NEW CINGULAR WIRELESS PCS, LLC (AT&T)
PETITION FOR A DECLARATORY RULING,
PURSUANT TO CONNECTICUT GENERAL
STATUTES §4-176 AND §16-50K, FOR THE
PROPOSED MODIFICATIONS TO AN EXISTING
WIRELESS TELECOMMUNICATIONS FACILITY
AT THE SIMSBURY VOLUNTEER FIRE
DEPARTMENT LOCATED AT 345 BUSHY HILL
ROAD, SIMSBURY, CONNECTICUT.

PETITION NO. 1373

AT&T's RESPONSES TO SITING COUNCIL INTERROGATORIES
SET ONE

SHEET NUMBER:
Z-3

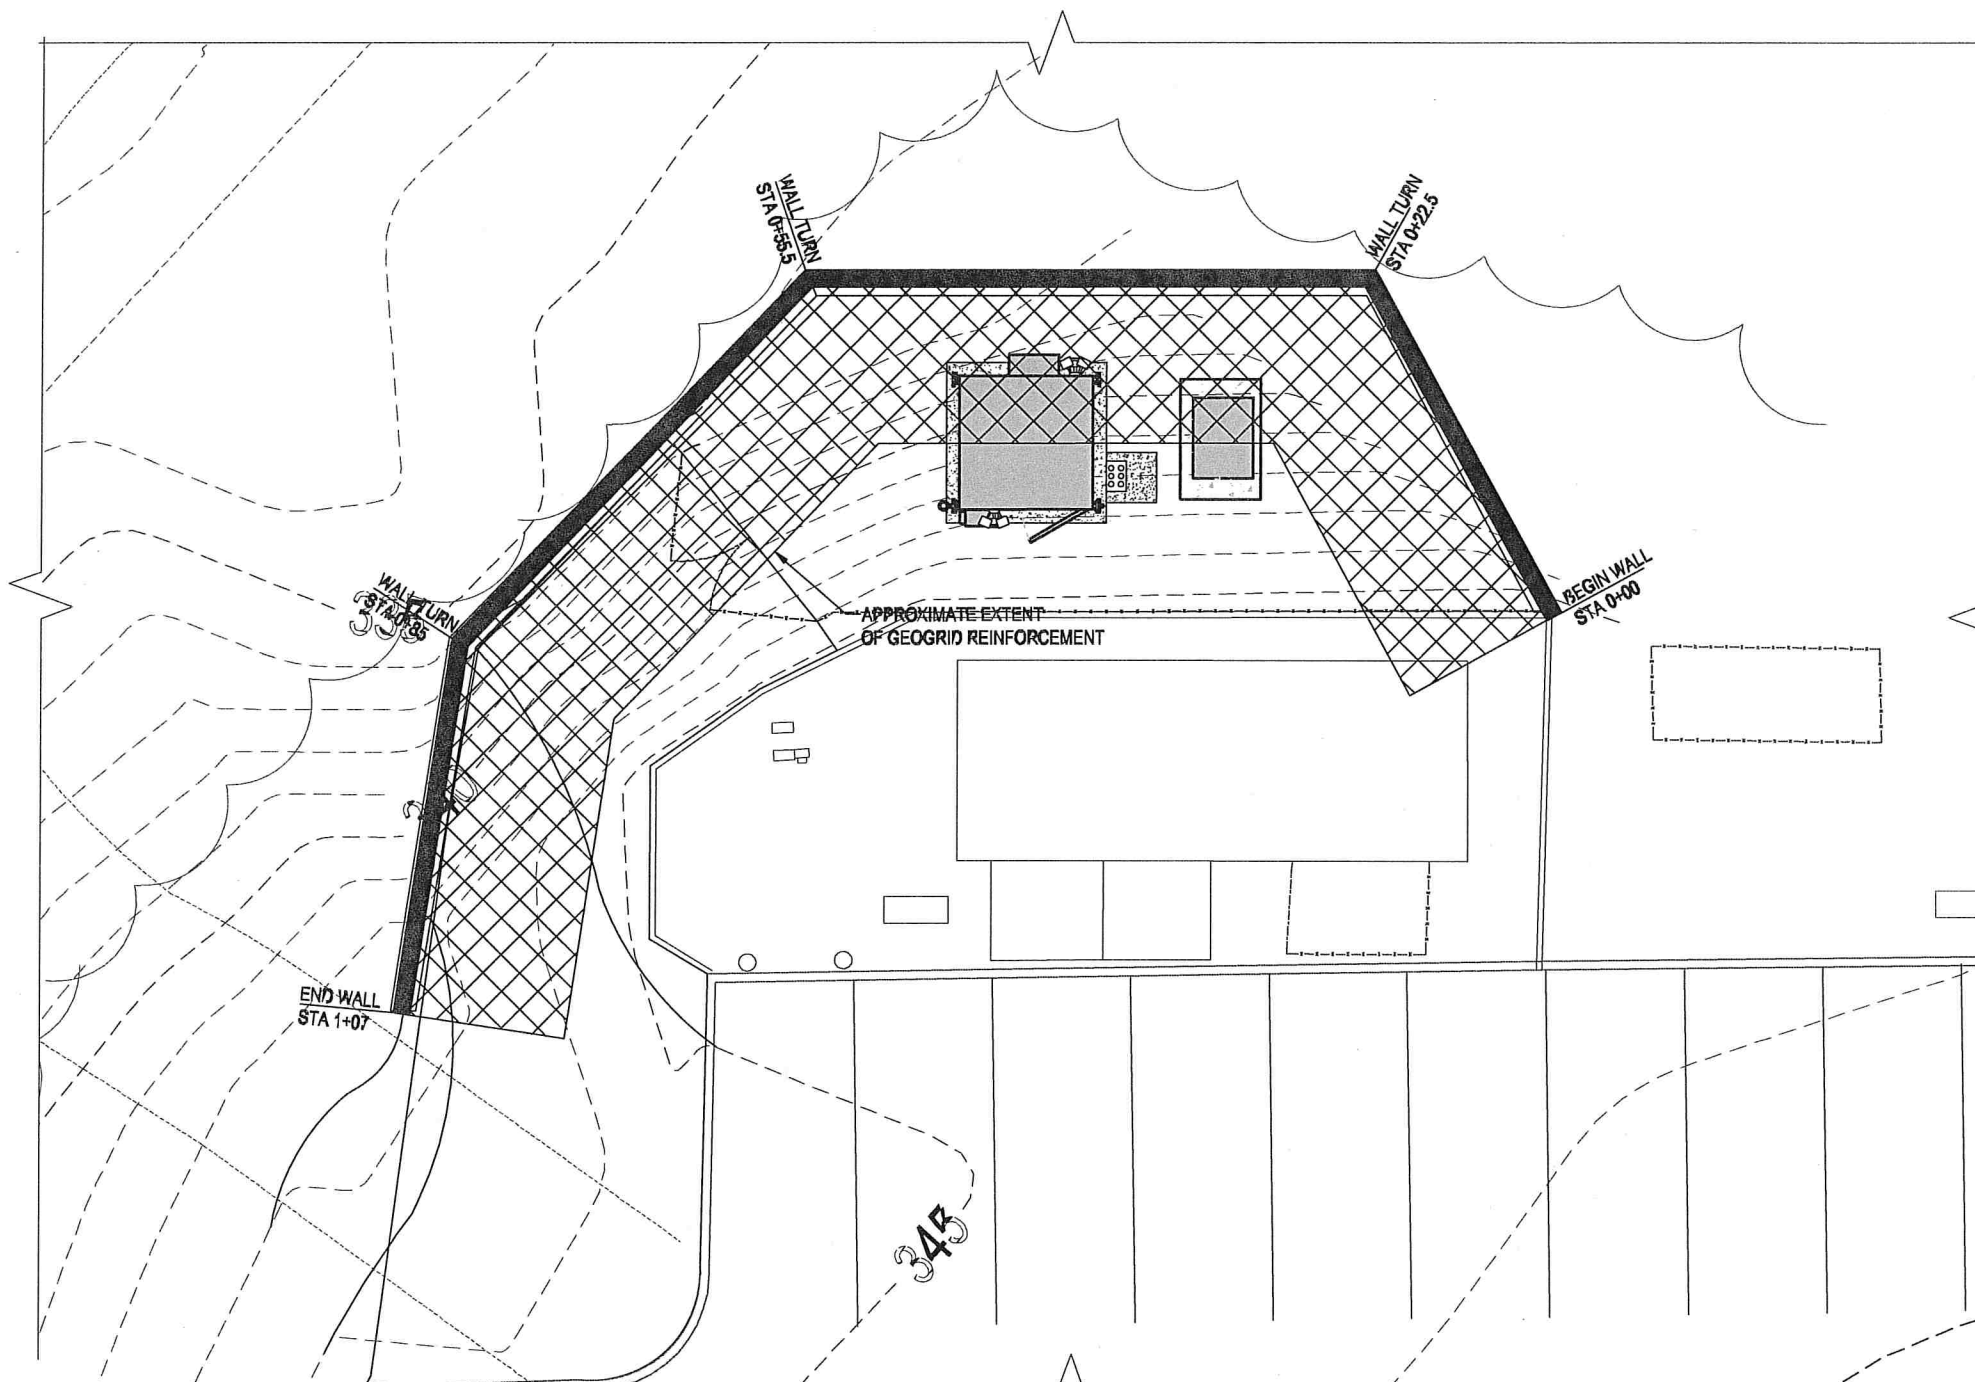
- Q4. Estimate the amount fill that would be required to develop the access road/compound area.
- A4. *Approximately 200 cubic yards of fill will be required to develop the access road and compound area. Please refer to Sheet Z-4 of the enclosed Revised Site Drawings.*

- PLAN ENTITLED "SIMSBURY FIRE STATION PREPARED BY EBI, DATED: 04/11/14 WERE PROVIDED BY SMARTLINK. MASER CONSULTING CONNECTICUT HAS NOT VERIFIED PROPOSED GRATING.
- AT&T LEASE AREA REQUIRES 200 YD³ OF BACK FILL FOR LEVELING.
- AT&T LEASE AREA REQUIRES REMOVAL OF ~12 TREES WITH A TRUNK DIAMETER >= 6"

FENCE DETAIL
SCALE: NTS

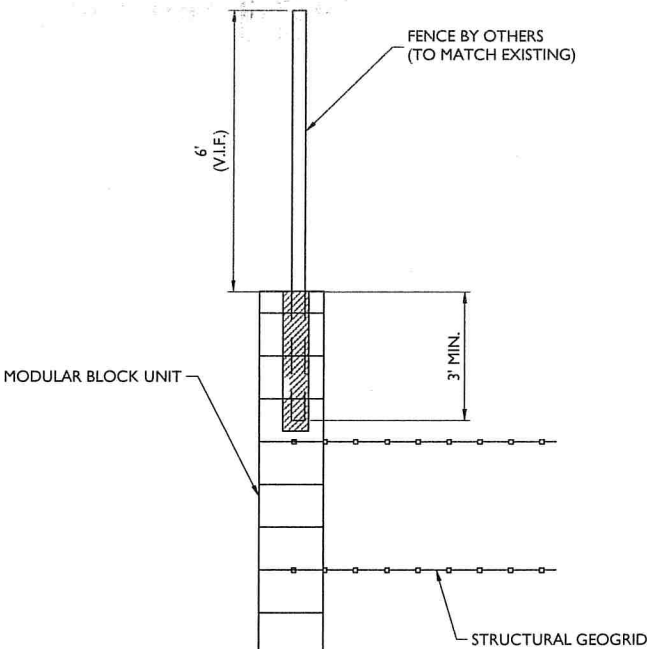
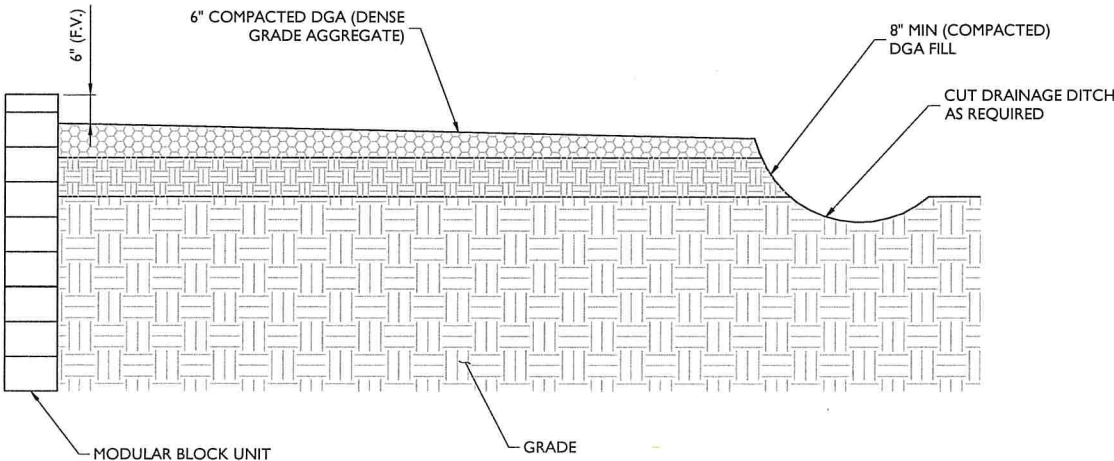
- Q6. What is the height of the proposed chain link fence?
- A6. *The height of the proposed chain link fence surrounding the compound will be approximately 6 feet high and will mirror the height of the fence surrounding the existing compound. Please refer to Sheets Z-2 and Z-6 of the attached Site Drawings for details of the proposed chain link fence.*

will be installed around the proposed equipment compound and along the top of the wall. No additional barriers or safety rails are proposed. Please refer to Sheets Z-2, Z-4, Z-5 and Z-6 of the enclosed Site Drawings for details of the proposed retaining wall and chain link fence.
